Charlotte Historic District Commission

Agenda Supplement

January 14, 2026

Supplement and response to staff comments.

2010 The Plaza, Building 1 and Building 3 comparison

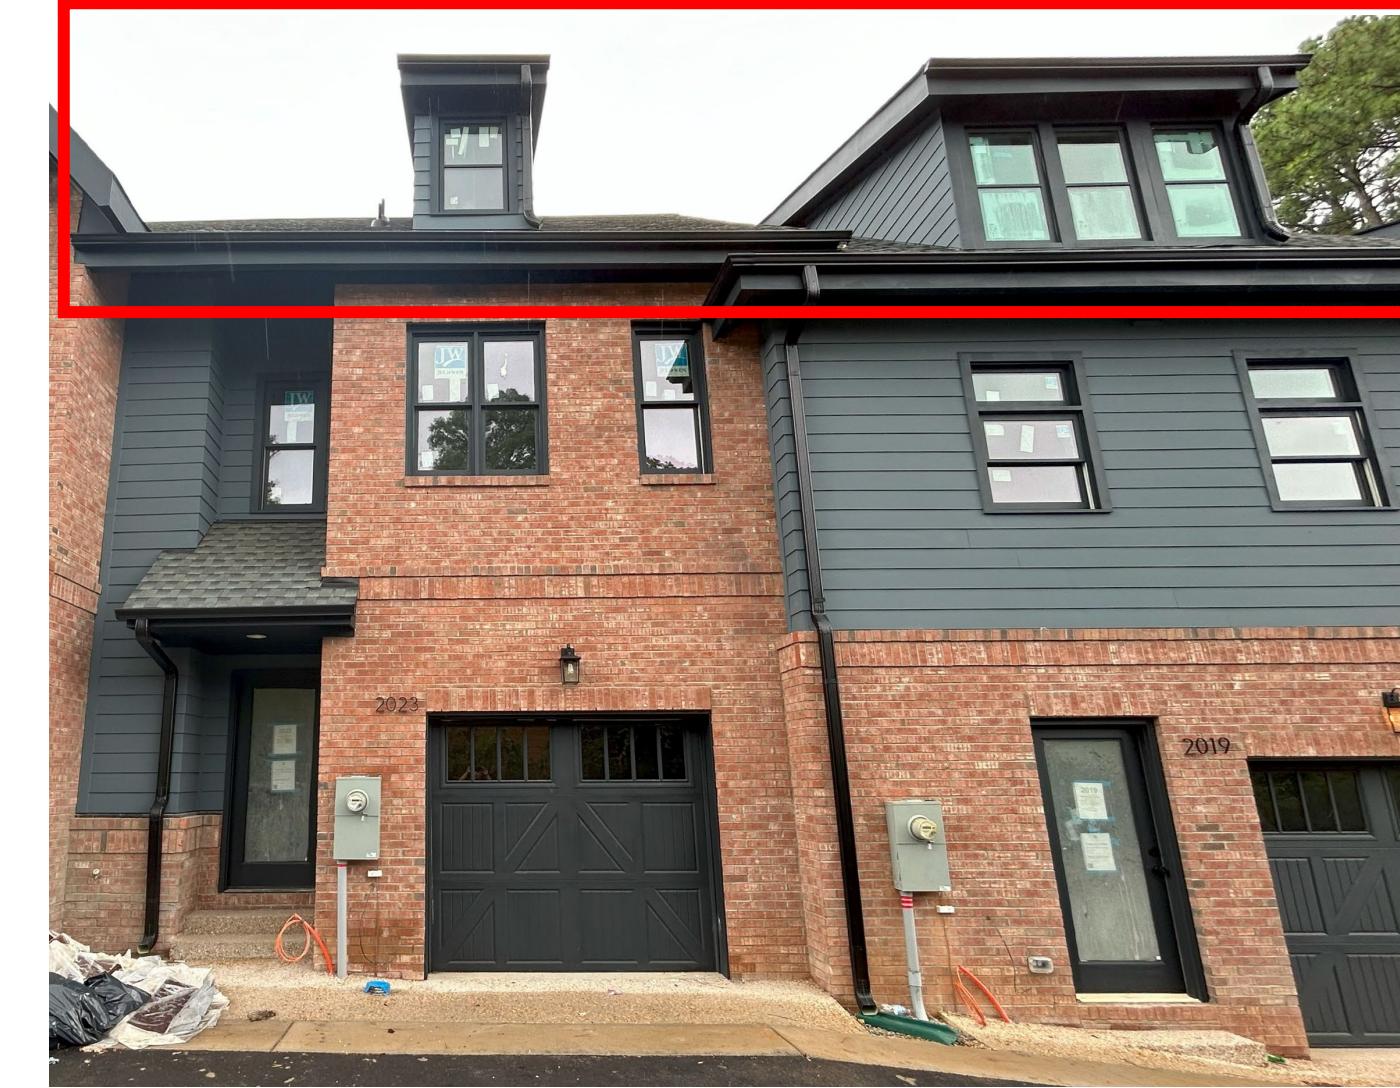
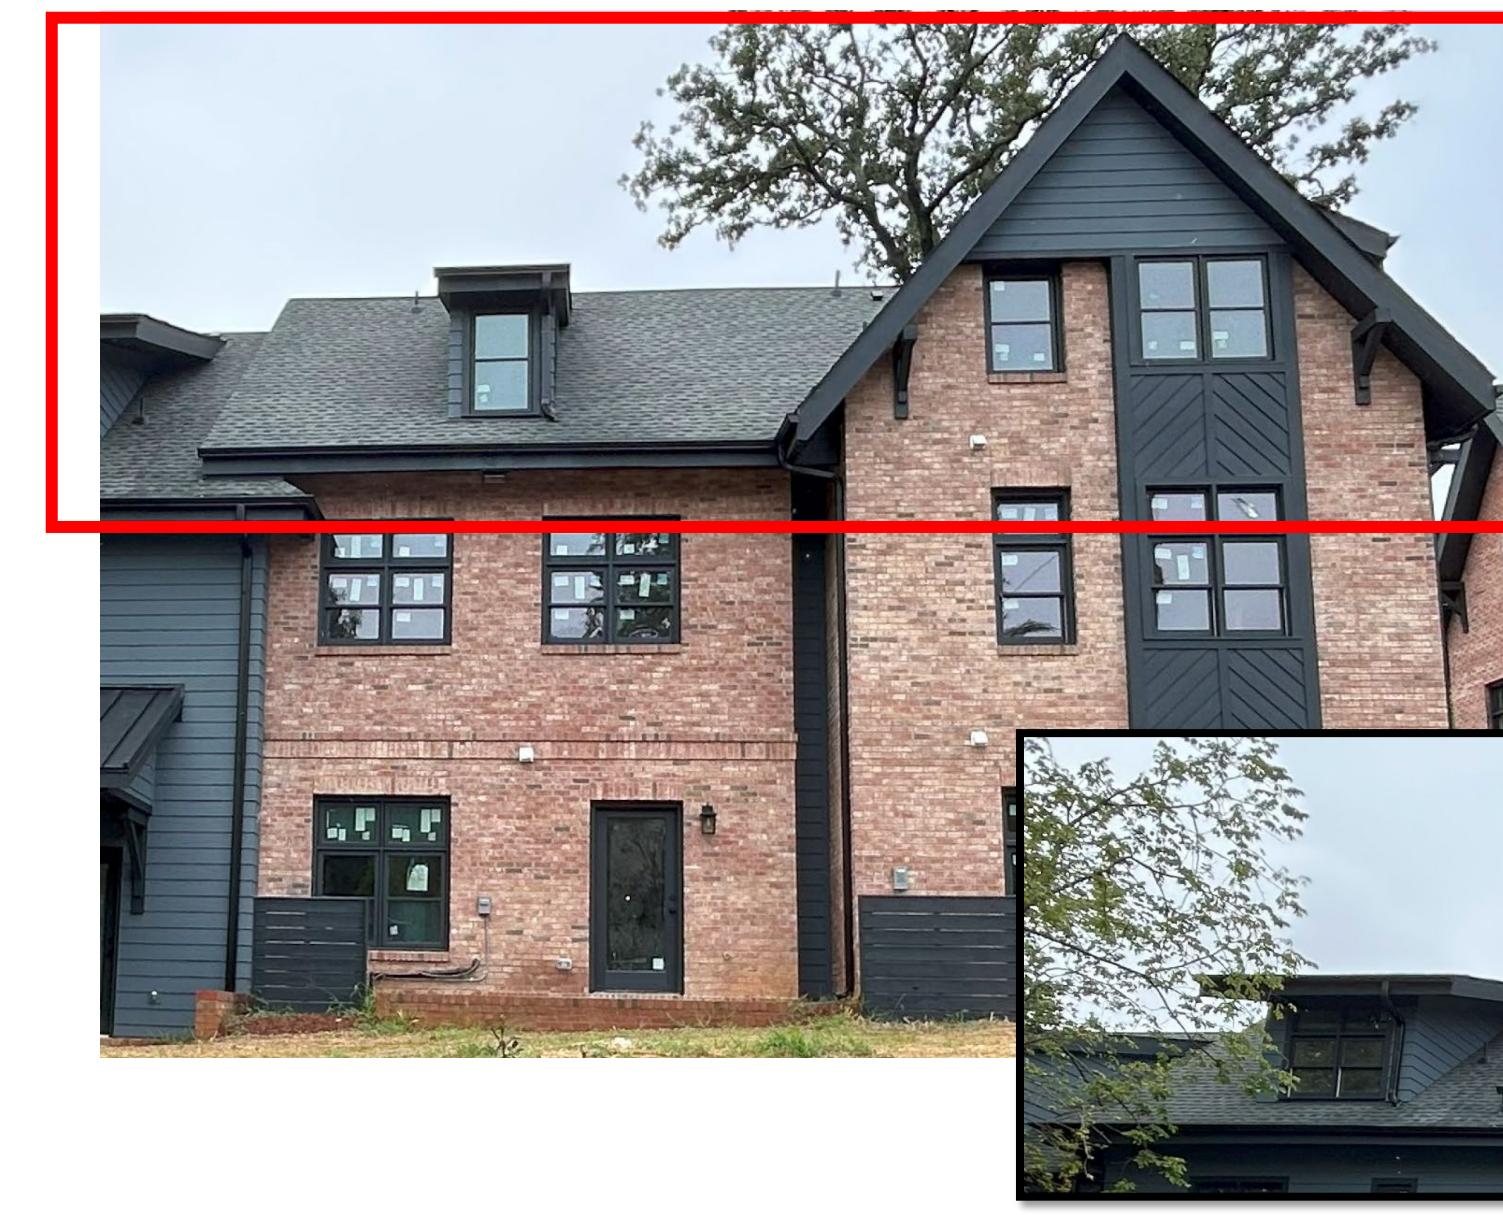
For the panel design noted in the Agenda Supplement, Slide 10, item 3(b), the diagonal design shown shall be changed to vertical lap siding in the center bay.

For Door and Window changes, the primary entries into the residences shall be the 1/3 glass with divided lights, 2/3 panel Craftsman style wood doors. All entries must be a Craftsman-style door. This includes any door that is exposed to pedestrian traffic, whether it's on an alley or private entry.

2010 The Plaza, Building 1 and Building 3 comparison

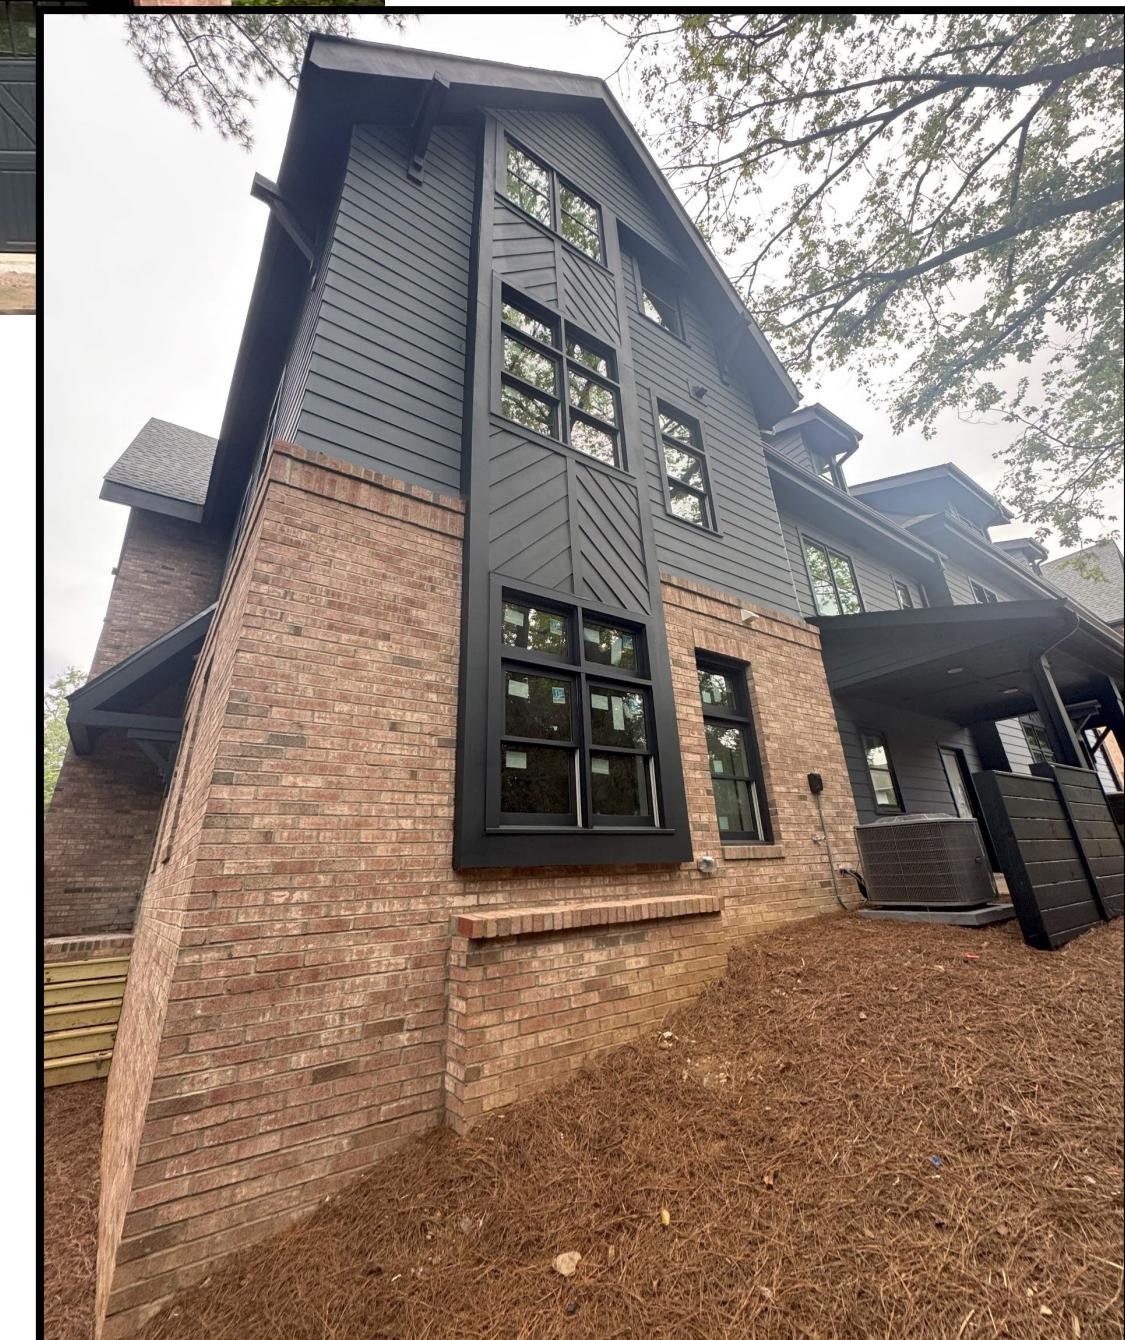
The roof changes for the north, south, and west elevations with the shallower shed roof pitches from a 6 pitch to a 4 pitch are approved.

4 ENLARGED PLANTER PLAN
1/2" = 1'-0"

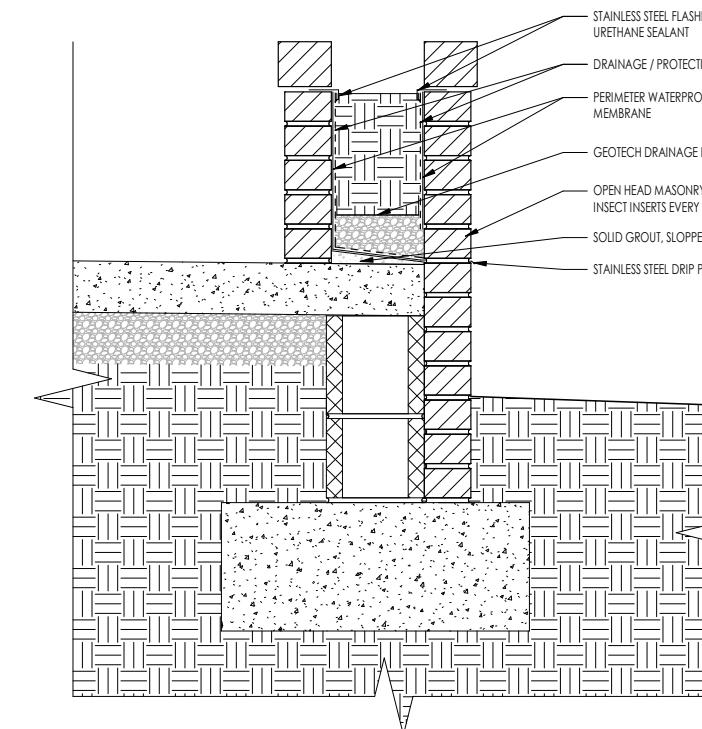
8. THE ENTRY PATIO CONFIGURATION WITH THE BRICK PLANTER WAS NOT FULLY REVIEWED AT THE LAST MEETING. THE PROPOSED BRICK PLANTER IS THE PREFERRED RE STUDY OPTION AS THE COMMISSION WAS PREPARED TO APPROVE IT THE LAST MEETING.

SUPPLEMENTAL INFORMATION- PLANTER, BRACKET, WINDOW, AND DOOR DETAIL

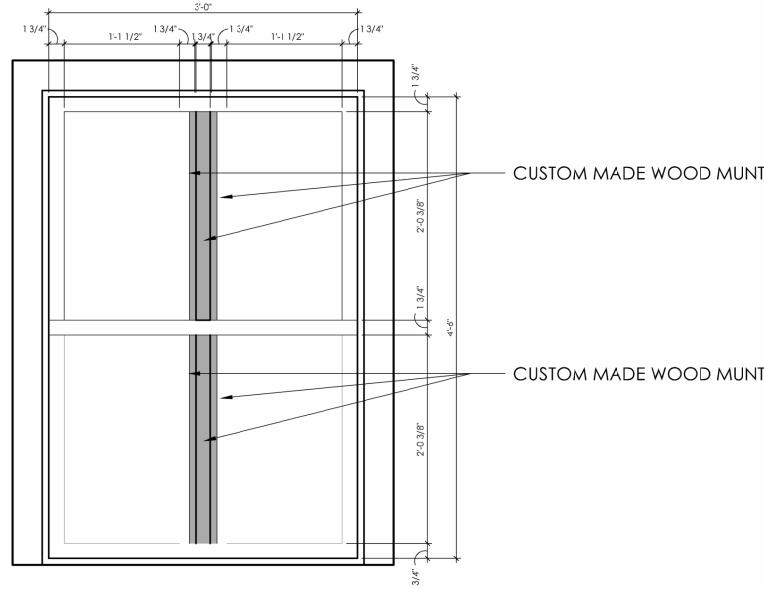
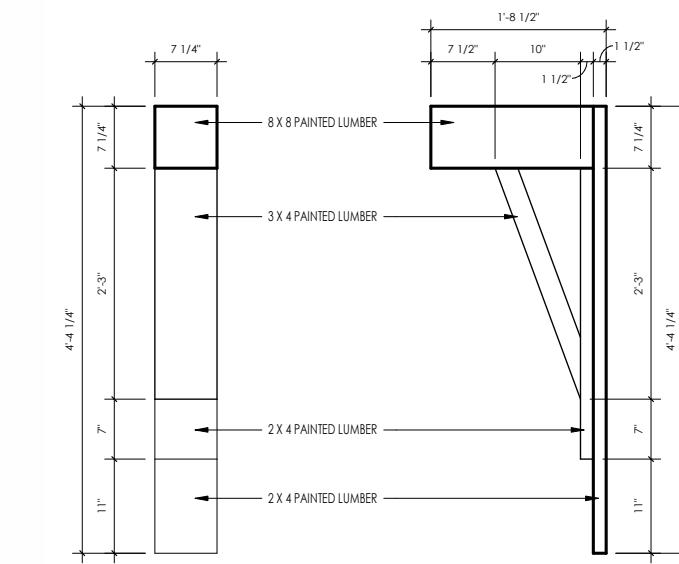
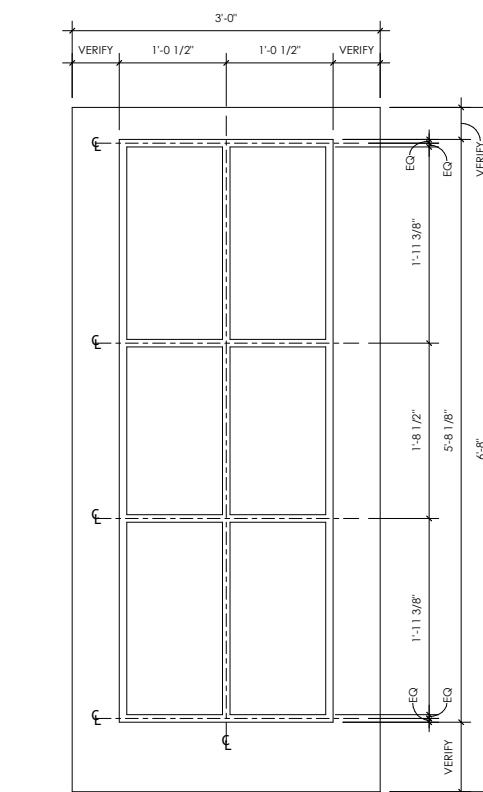
CUSTOM WOOD WORKER THAT SHALL PROVIDE CUSTOM SASHES WHERE DOUBLE HUNG WINDOWS MATCH THE APPEARANCE AND QUALITY OF THE ADJACENT WINDOWS. SHOP DRAWINGS WILL BE PROVIDED TO STAFF FOR REVIEW. SASH DETAIL PROVIDED MEETING THE REQUIREMENTS FOR WINDOWS AND DOORS.

3. DOOR RESTUDY IS INCLUDED ON THE PROPOSED ELEVATIONS OF THE SUBMITTAL. THE INTENT IS TO PROVIDE SOLID 1/3 LITE DOORS FOR ALL PUBLIC FACING ELEVATIONS AND DIVIDED LITE DOORS PER THE PROVIDED DETAILS ON THE INWARD FACING DOORS.

5. DETAILED DIMENSIONS FOR BRACKET A PROVIDED IN SUPPLEMENTAL INFORMATION.
6. AS BUILT DRAWINGS FOR NORTH AND SOUTH ELEVATIONS WITH UNIT DIMENSION WIDTHS AND DORMER WIDTHS PROVIDED.
